1822 Bank Street

URBAN DESIGN BRIEF - R2

MARCH 17, 2025

RESPONSE TO URBAN DESIGN COMMENTS

VIEW FROM ABOVE NORTHWEST SHOWING 45 DEGREE ANGULAR PLANE

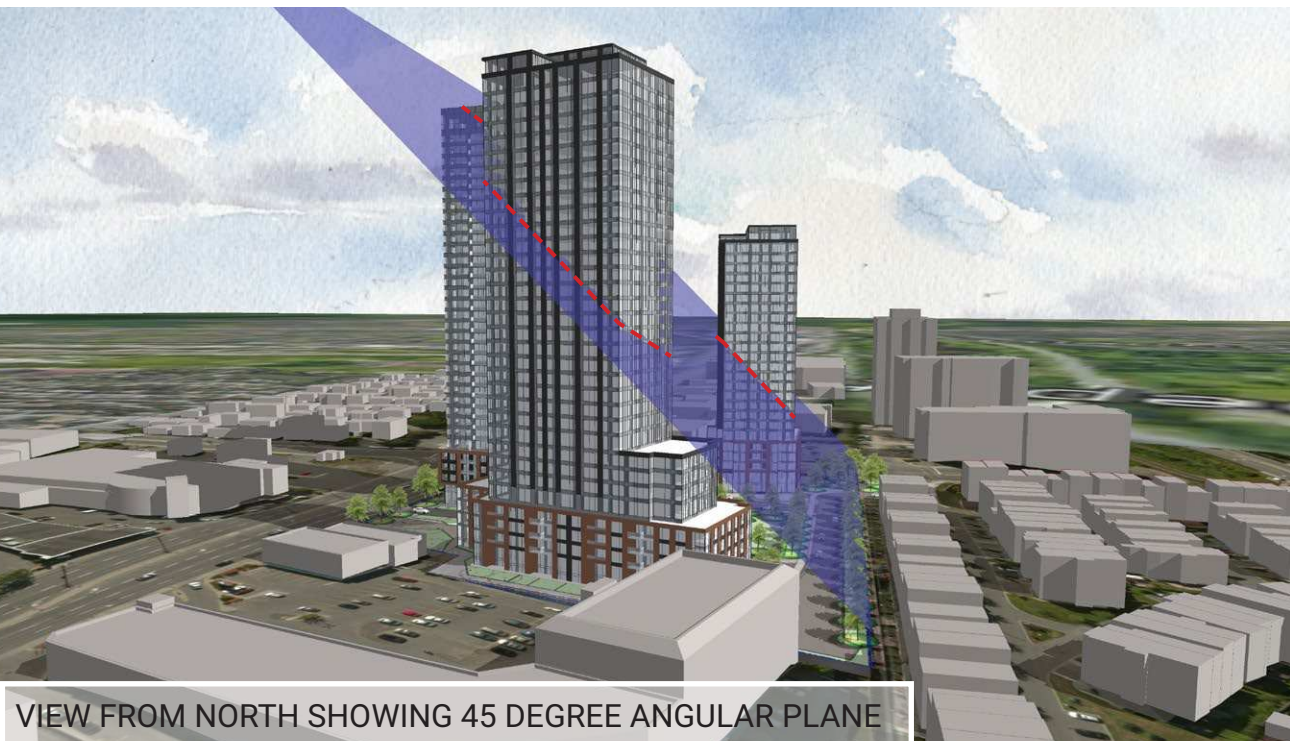
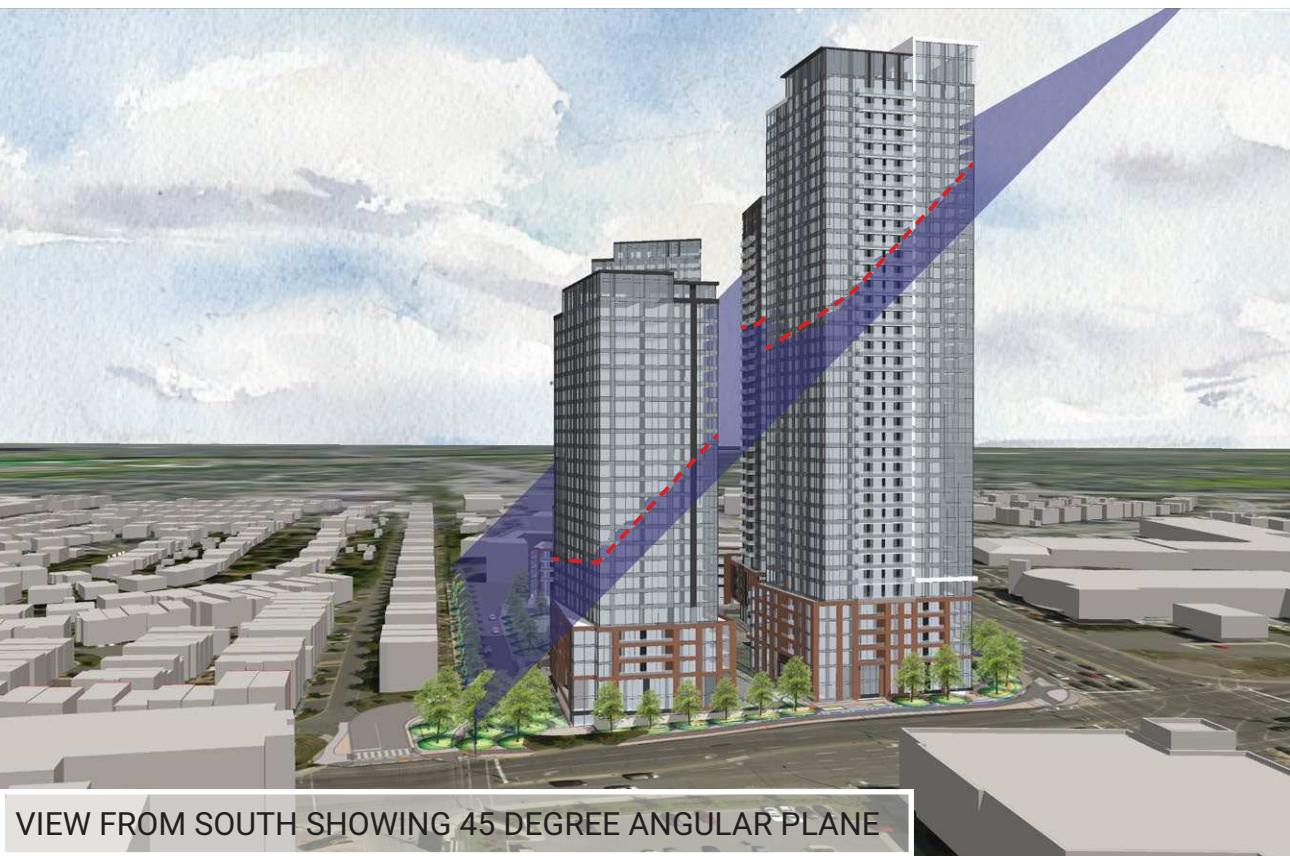
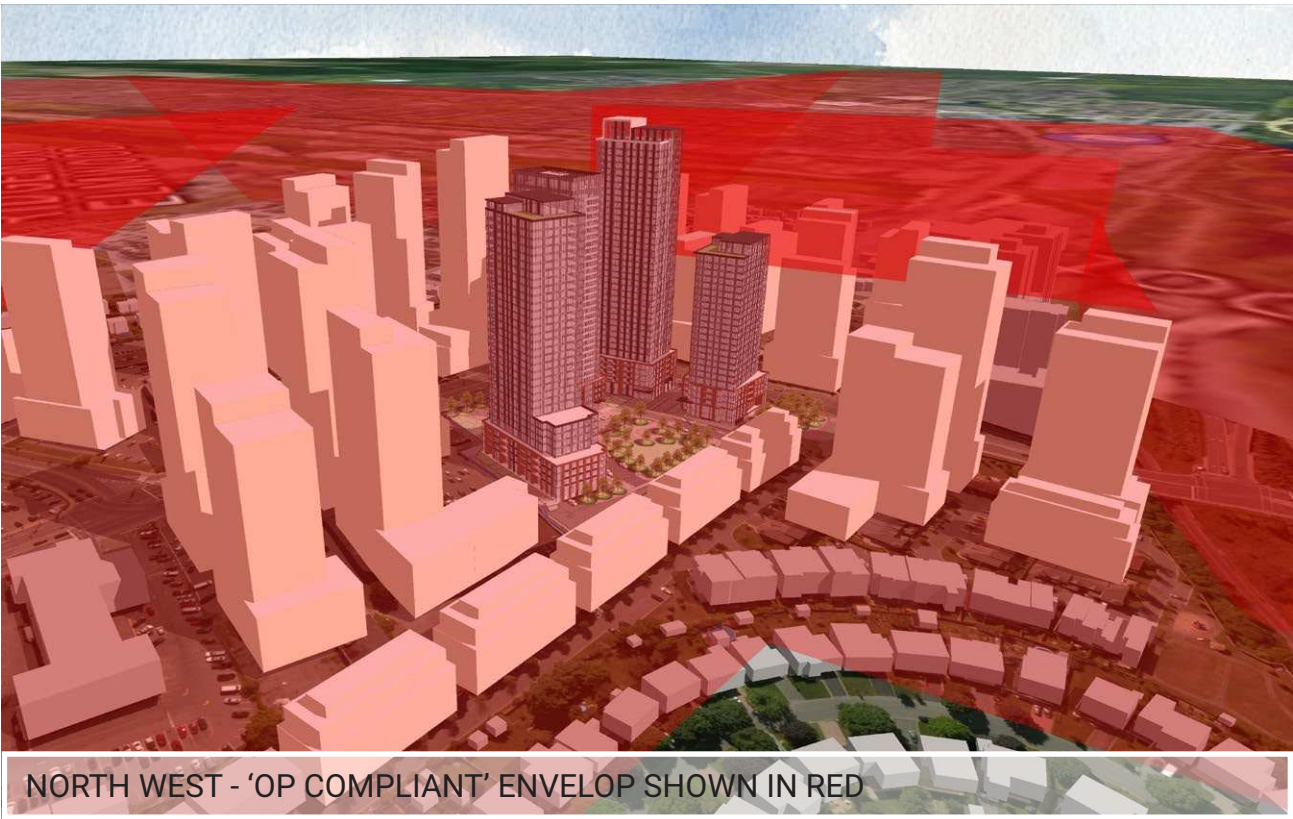
41. Ensure effective built form transition, guided by the application of angular planes.

17. Towers 1 and 4 protrude significantly above the 45-degree angular planes as shown on page 20 of the submitted Design Package.
- i. Tower 1 – At the current proposed location and floorplate size, the height of the tower appears to be too tall.
 - ii. Tower 4 – The height should be reduced. It is interesting to note that if Tower 4 is a 16-storey building, permitted by the Secondary Plan, it will not protrude above the angular plane.

28. Slide 20 of the Design Package demonstrates the buildings projecting above the angular plane. While the angular plane is not meant to be a rigid determination of heights, it does inform the general appropriateness of building heights. In this case, it seems to me that Building 4 should be reduced by several storeys. In addition to improving the building height transition, this would add more variation to the building heights.

Applicant: Please refer to the angular plane diagrams included in the UDRP submission set. We feel that the proximity to the transit station and future development potential under the OP justifies some elements of the development breaking the 45 degree angular planes. The trade-off the proposed development offers is providing the majority of the western edge as greenspace. This minimizes the number of the existing townhomes impacted by overlook / shadowing.

Applicant: We acknowledge that towers 1 and 4 protude through the angular plane. However we feel that this massing response is reason given the significant adjacent open space gained by locating the park at the west side of the property closest to adjacent low-rise. The park location serves to balance the impacts of the taller building forms. Additional, building 1 is the closest of the buildings to the new transit station, and therefore an appropriate location for a taller / higher density form.
